SUBJECT: Forwards revised Figure 8.3-8B, Sheet 13a, depicting addition of second fuse to control power circuits. Revised Figures 8.3-8B, Sheet 13b & 8.3-8B, Sheet 13e, also encl to clarify penetration protection curve, per 860828-29 meetings.

August 29, 1986
(NMP2L 0860)

Re: Nine Mile Point Unit 2
Docket No. 50-410

Sh 13a of 13

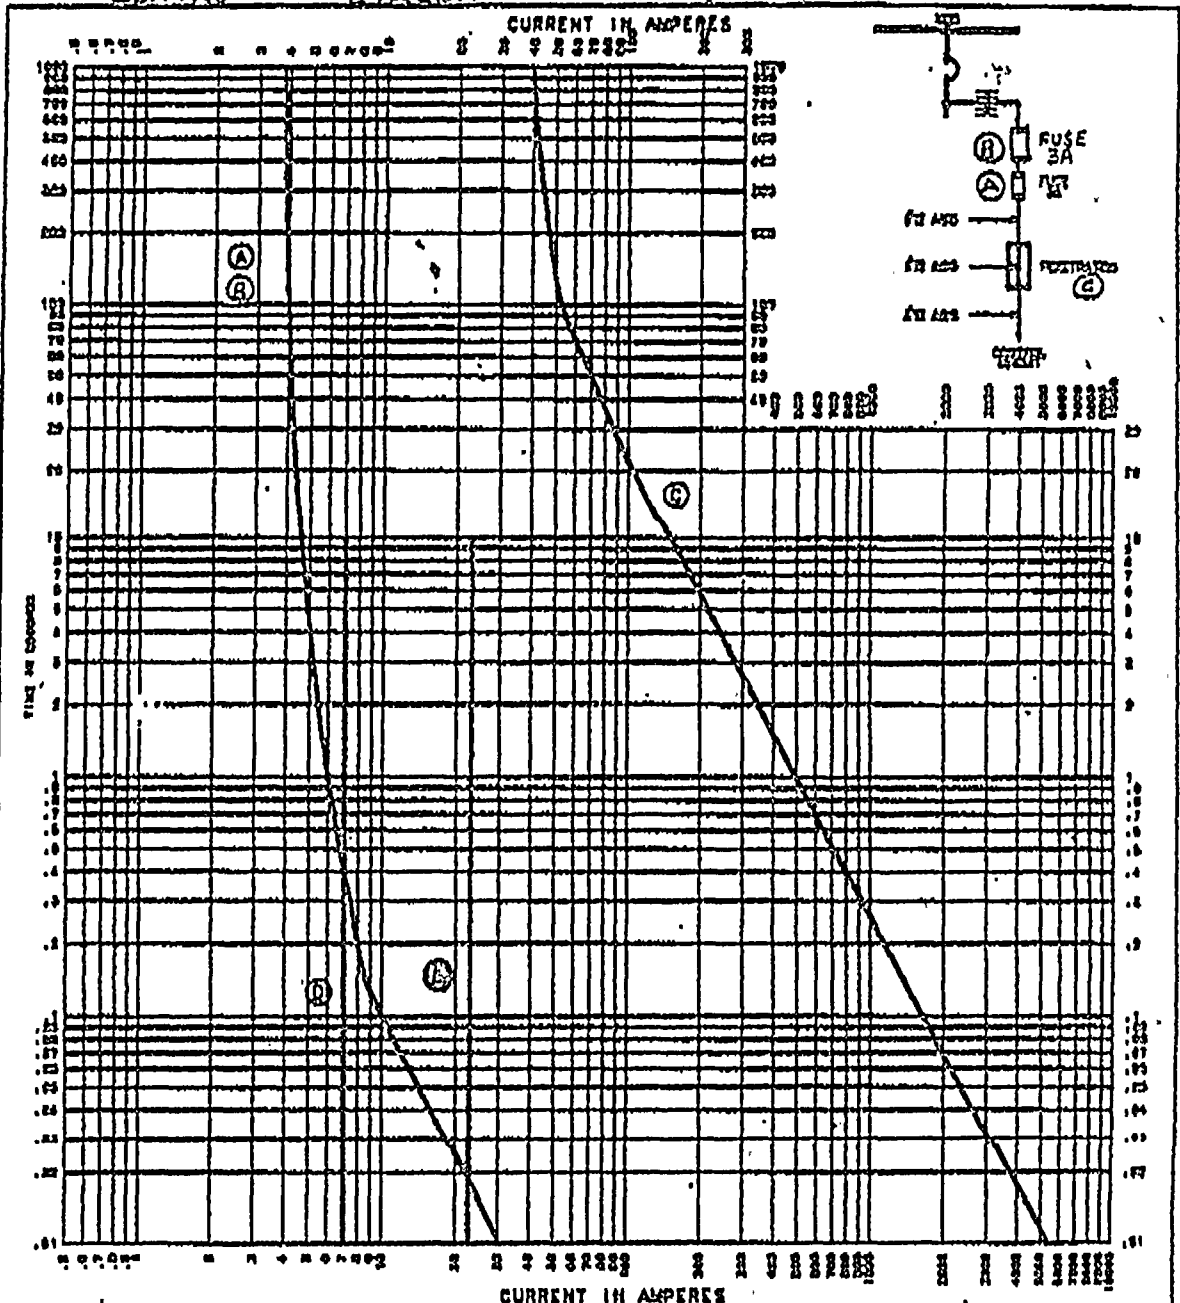
In a letter to you on August 22, 1986 (NMP2L 0842) we provided penetration protection information for various control power circuits. Your reviewer expressed a concern regarding the use of control power transformers for back-up penetration protection on a number of circuits (Figure 8.3-8B, Sheet 13a). While we believe that our design is acceptable, we have decided to enhance the protection of these circuits by installing a second fuse in these circuits. This work will be completed before the end of the "mini-outage" conducted within 12 months of commencing power operation.

Submitted with this letter is a revised Figure 8.3-8B, Sheet 13a depicting the additional fuse described above. Also included is a revised Figure 8.3-8B, Sheet 13b and a new page 2 to Figure 8.3-8B, Sheet 13e containing a note clarifying that penetration protection curve. These revised Figures were discussed with the NRC staff during meetings held on August 28 and 29, 1986.

SH 13a of 13 P1 of 2

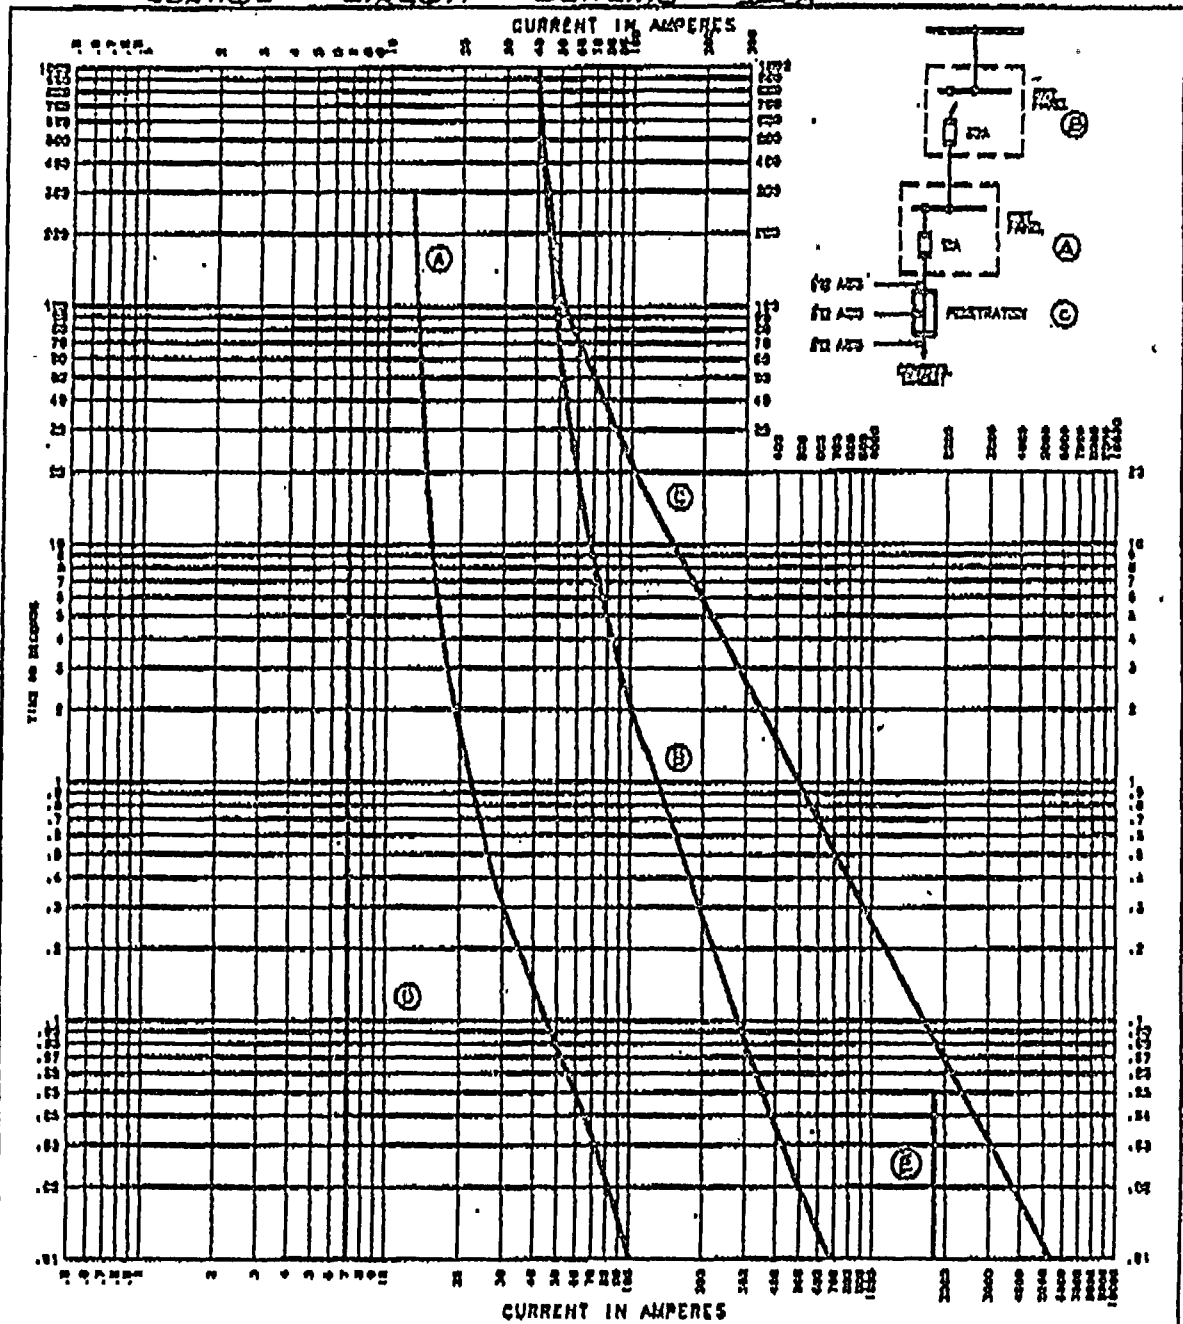
SEE NOTE ON SH.13 e. p 2 of 2

NOTE: The typical scheme IIIA on Figure 8.3-8B, Sheet 13e of 13 is for dc control circuits utilizing a contact signal from inside containment. Since the dc distribution system is ungrounded under a single line to ground fault, the system continues to operate as designed. Upon a line to line fault or a short, the circuit acts as though the contact was closed and draws the same current as it would under normal circumstances (less than 7 amps). Although a backup protection is provided for these circuits, it is not considered necessary to protect the integrity of penetrations. Therefore, the overlap between the penetration curve and the 30 amp fuse would not compromise the integrity of the penetration. The protection as provided conforms to the requirements of Regulatory Guide 1.63.
